PIECE-PART DATA AND REPLACEMENT PROCEDURES

B-, C-, G-, AND J-TYPE RELAYS

1.001 This addendum supplements Section A507.102, Issue 2.

1.002 This addendum is issued to cover piece-part data on the mounting screws when the No. 26A terminal punching is used with a B-, G-, or J-type relay.

Fig. 2 — B- and G-type Relays — Bottom View — Initial Design

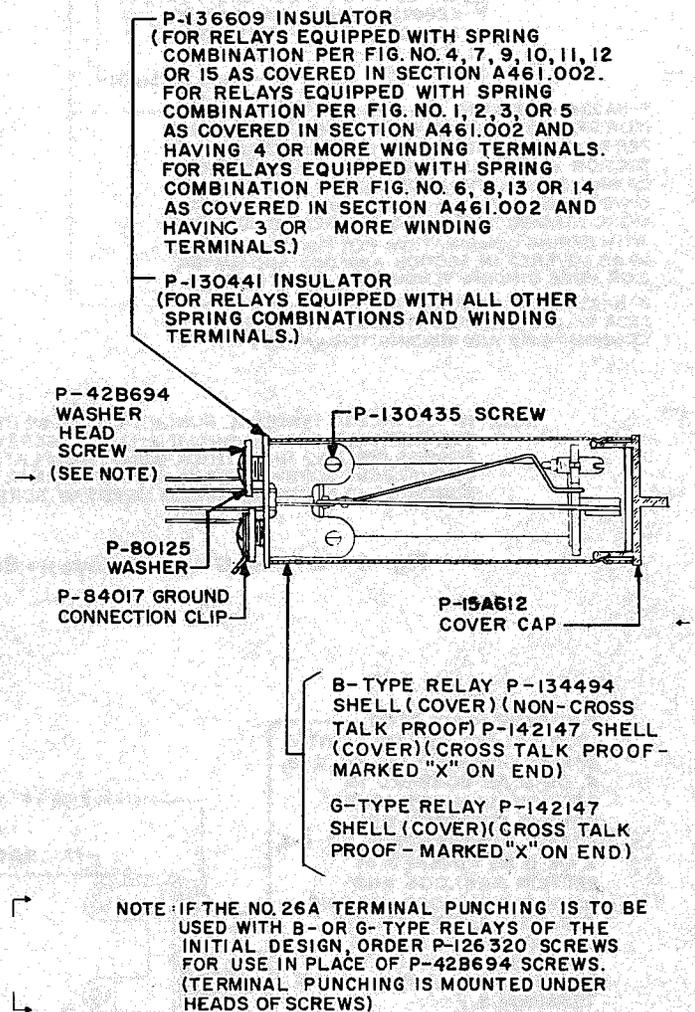
(a) Fig. 2, 4, and 7 — revised.

Fig. 4 - B- and G-type Relays — Bottom View — Modified Design

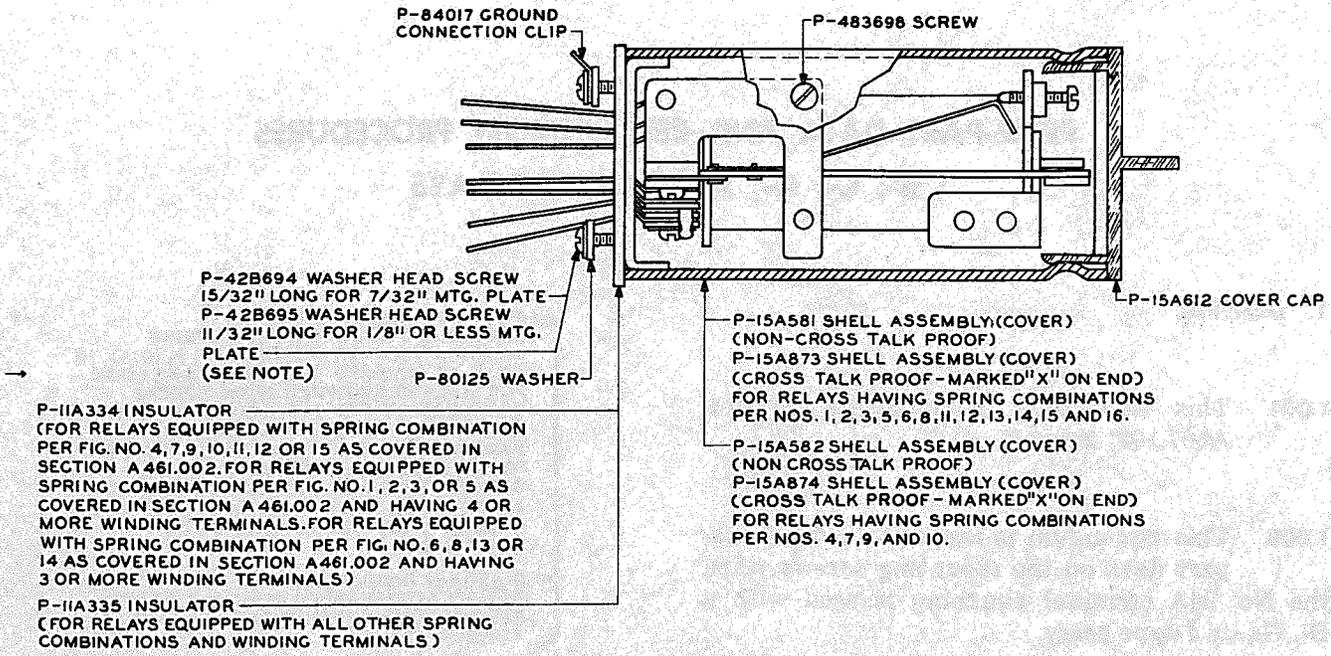
NOTE: IF THE NO. 26A TERMINAL PUNCHING IS TO BE USED WITH B- OR G- TYPE RELAYS OF THE MODIFIED DESIGN, ORDER P-126320 SCREWS FOR USE IN PLACE OF P-42B694 SCREWS FOR 7/32 INCH THICK MOUNTING PLATES, AND P-111552 SCREWS IN PLACE OF P-42B695 SCREWS FOR 1/8 INCH OR THINNER MOUNTING PLATES. (TERMINAL PUNCHING IS MOUNTED UNDER HEADS OF SCREWS)

Fig. 7 - Shells (Covers) and Cover Plates for J-type Relays

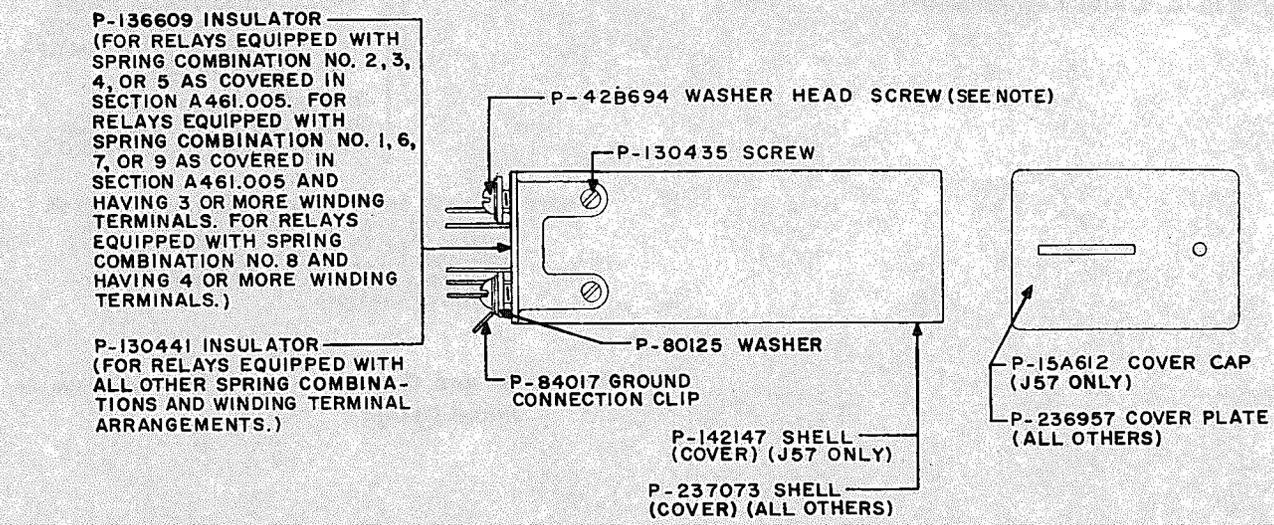
NOTE: IF THE NO. 26A TERMINAL PUNCHING IS TO BE USED WITH A J-TYPE RELAY, ORDER P-126320 SCREWS FOR USE IN PLACE OF P-42B694 SCREWS. (TERMINAL PUNCHING IS MOUNTED UNDER HEADS OF SCREWS)
